FAIRFAX COUNTY, VIRGINIA

MEMORANDUM

SUBJECT: STAFF ANALYSIS OF THE CONCEPTUAL PLAN FOR THE
RESTON CORPORATE CENTER - RZ 86-C-119

CONCEPTUAL PLAN - RZ 86-C-119

CONCEPT PLAN

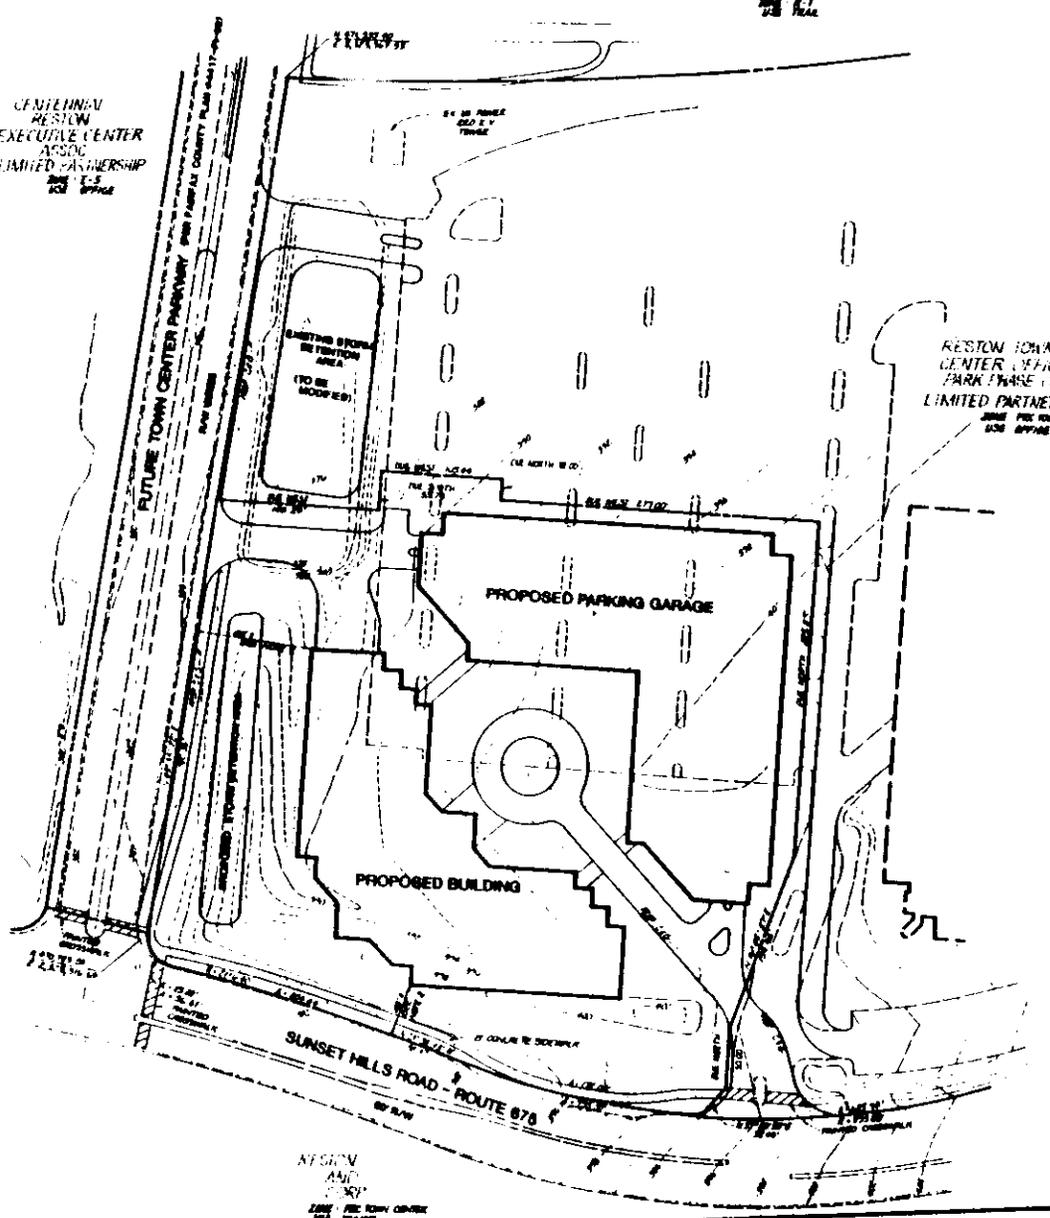
- o The previous commitments for transportation improvements associated with the RZ 86-C-119 application should be continued.
- o Access is proposed to Town Center Parkway to the west. This will be a right-in/right-out entrance only due to the raised median on Town Center Parkway. Therefore, it would be desirable for this site to have access to the parking lot to the north. This connection would provide left turn access to the site from the north.

- o A potential rail station is planned in the vicinity of this site. To provide for pedestrian access to and from the rail station, it would be desirable for the applicant to address the following issues:

- (1) Pedestrian crossing at the intersection of Future Town Center Parkway and Sunset Hills Road (painted surface cross-walks, pedestrian signal, etc.).

- (2) Sidewalks along Sunset Hills Road to allow for access to and from the potential future rail station.
 - (3) A bus pull-off and passenger waiting area on Sunset Hills Road.

Comments on the conceptual plan from the Office of Transportation are included as Attachment 4. The applicant has addressed these comments as follows: 1) RZ 86-C-119, as stated previously in this memorandum, is bound by the Reston Town Center transportation proffers and this conceptual plan application proposes no changes to these proffers; 2) a painted crosswalk at the Sunset Hills/Town Center Parkway intersection and an eight (8) foot wide sidewalk along the site's Sunset Hills Road frontage are shown on sheet 2 and; 3) a note stating that the applicant, at the time of site plan, will work with the County on the location of a bus shelter is on sheet 3. The Office of Transportation states that it would be desirable to provide interparcel access between the subject property and the adjacent office development in order to facilitate a full turn access from the subject property onto Town Center Parkway. As proposed, the subject property would have only right in/out access onto Town Center Parkway with full turn access onto Sunset Hills Road. While such interparcel access would be desirable, the adjacent office development is surrounded by a security fence and a guard station is located at the Sunset Hills entrance to the property. Interparcel access is thus precluded.

CONCEPTUAL LANDSCAPE AND SCREENING PLAN

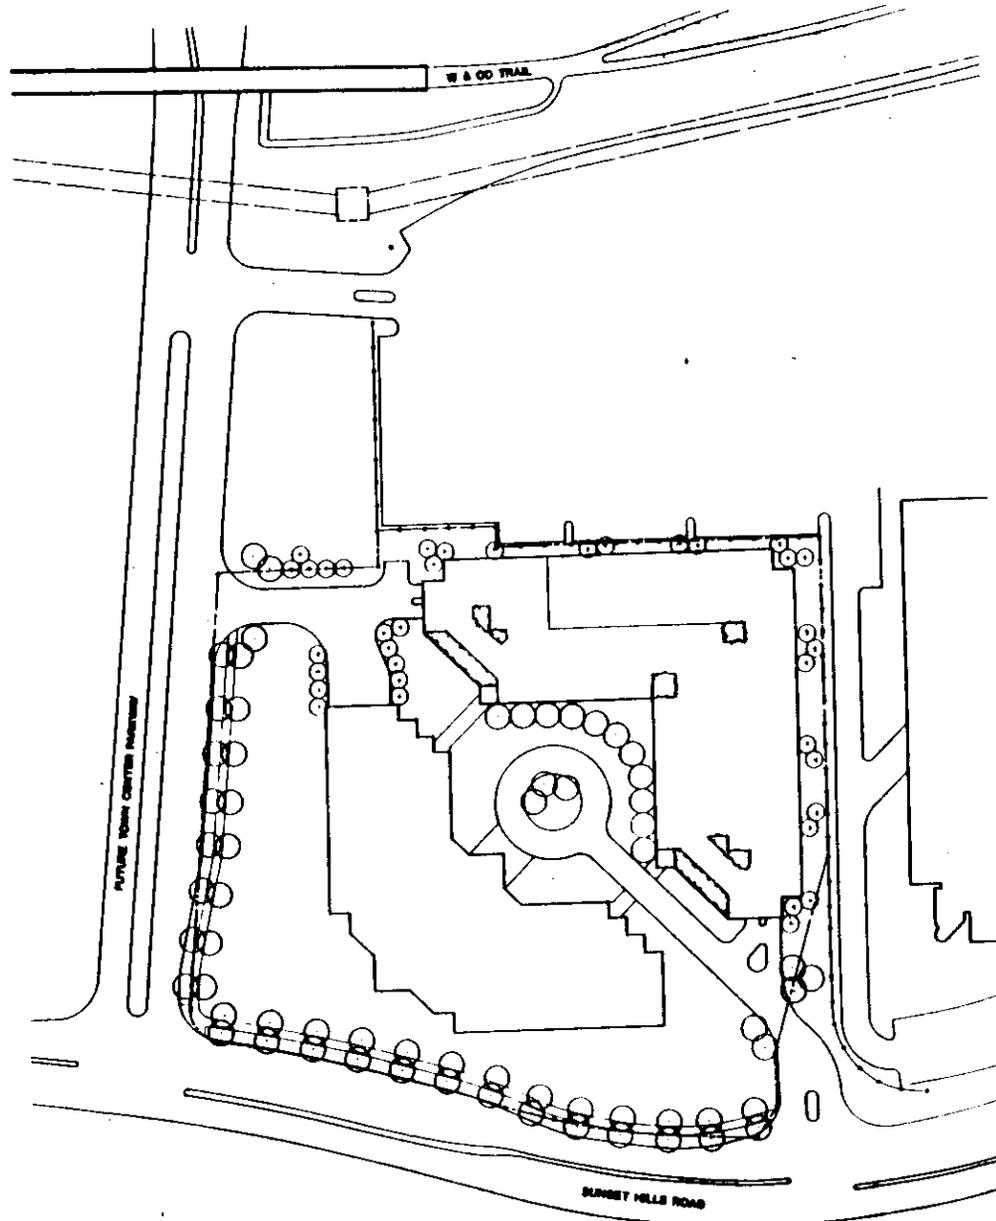
Landscaping and architectural elevations are two (2) issues raised by the Planning Division in the review of the conceptual plan. The applicant has submitted a conceptual landscape plan which is sheet 4. Notes on this plan state that a detailed landscape plan will be submitted to the County Arborist for review and approval. This plan, according to the notes, will provide for streetscape plantings compatible with the Reston Town Center, screening of the parking garage and service areas with evergreen trees and shrubs and a mixture of landscape materials around the office structure. Architectural elevations for the office structure and parking garage have been submitted to the Reston Town Center Design Review Board in conformance with the Town Center proffers. It should be noted that architectural elevations are not an item listed to be submitted with the conceptual plan per the proffers for RZ 86-C-119.

Additional Comments: The parking structure is a significant feature of this development; therefore, its design and use of building materials should be compatible and well coordinated with the office building. Special landscaping should be provided along the road frontage and the court yard.
